David Sands - November 2025 - Updated TPO Tree Comments based on Applicants Amended Plans

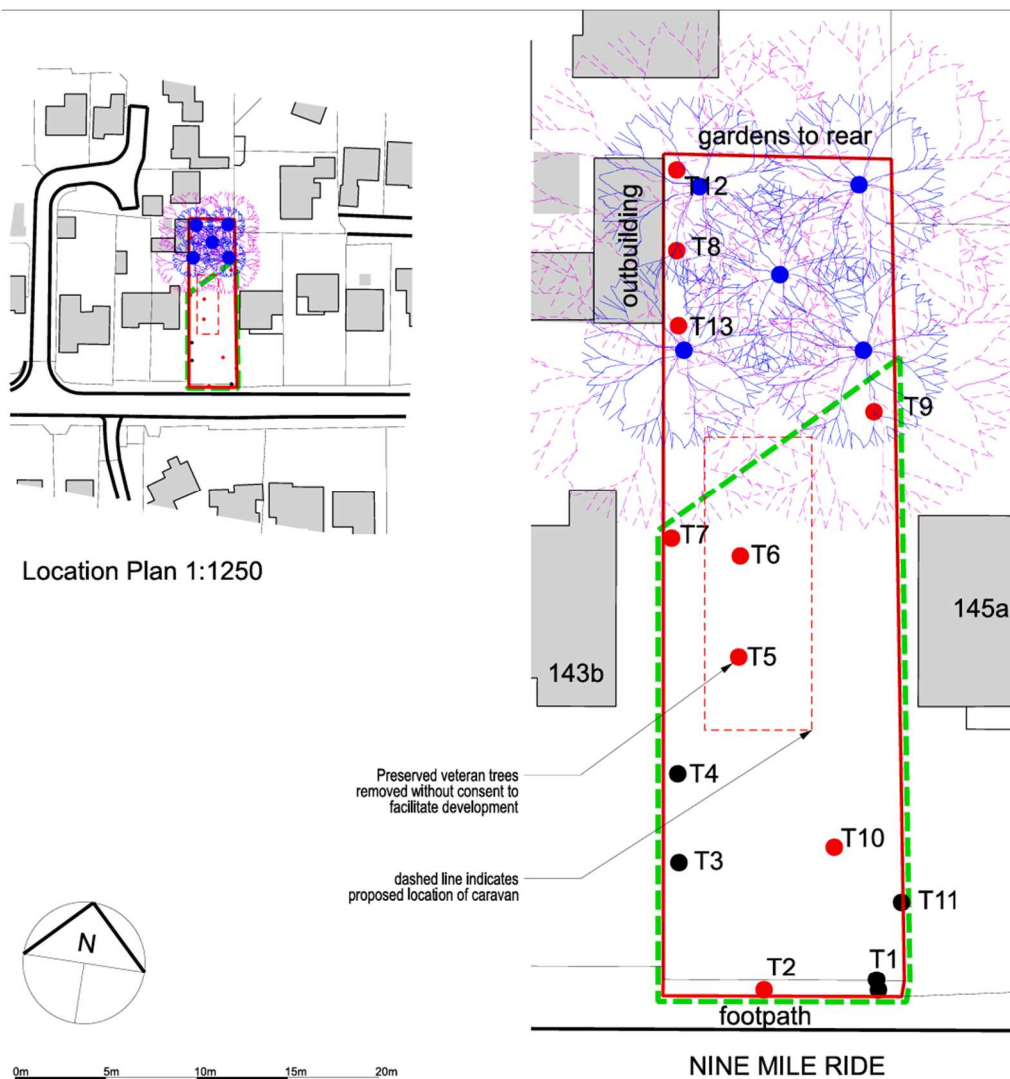
The 2 trees previously on my boundary have been moved. There is still 1 tree directly on the boundary. This will have significant overhang and shade into my garden. I strongly object to this positioning of a TPO Tree.

To illustrate the problem I have added tree canopies to the plan below.

Note that I have never had any previous shade or overhang issues from that plot. This is an added disadvantage and obligation to my property in terms of blocking of light and future maintenance of a preserved tree.

Original Tree Locations covers by TPO (283/1983) with development structure in app

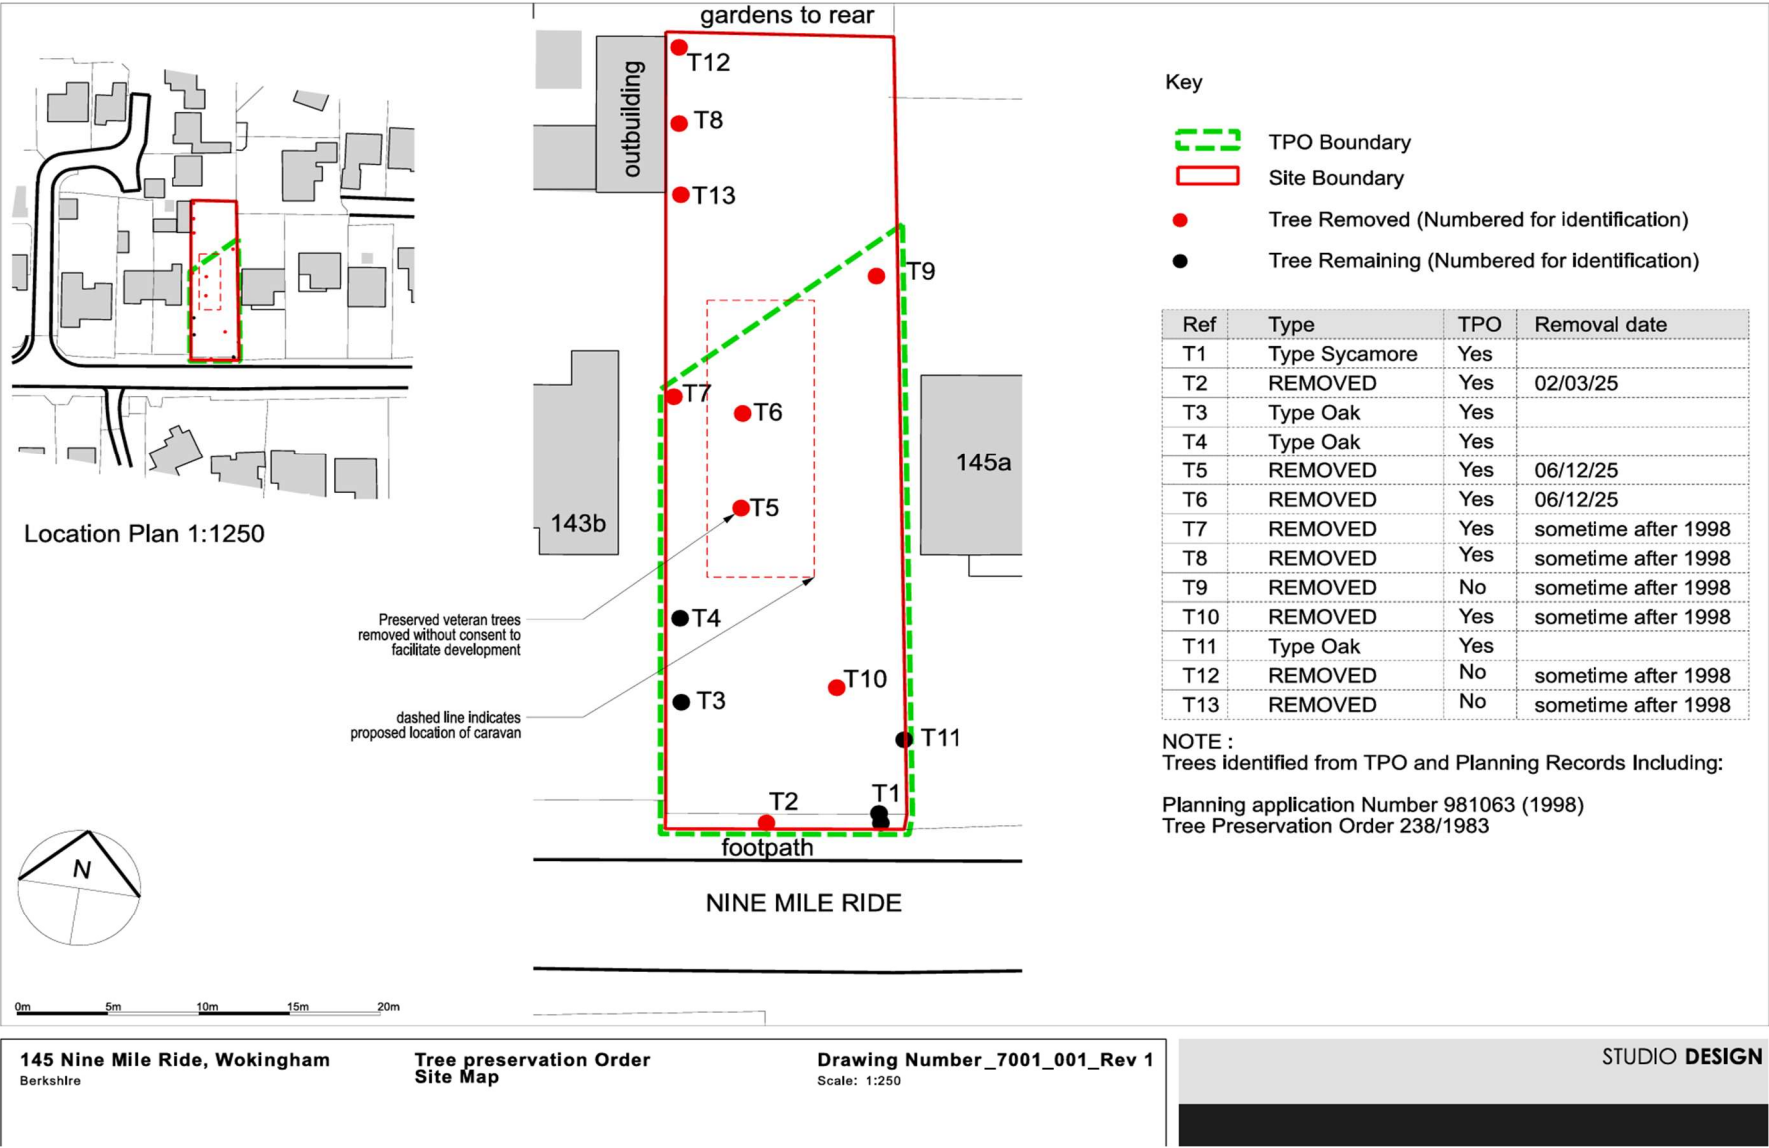
I have put together a diagram of the Original Tree Locations together with the proposed site layout. The original TPO covered the trees as a “group” classification.

It is Wokingham TPO policy that replacement trees should be replanted in the original location.

The proposed replanting does not adhere to that policy and is designed to facilitate development at the site by planting singly around the edge of the plot outside the TPO Area. The replanting should be done in the original locations.

After disputing the TPO Officers suggestions, the Wokingham TPO Team have informed me the new tree locations should be more central to the plot (email 4th July).
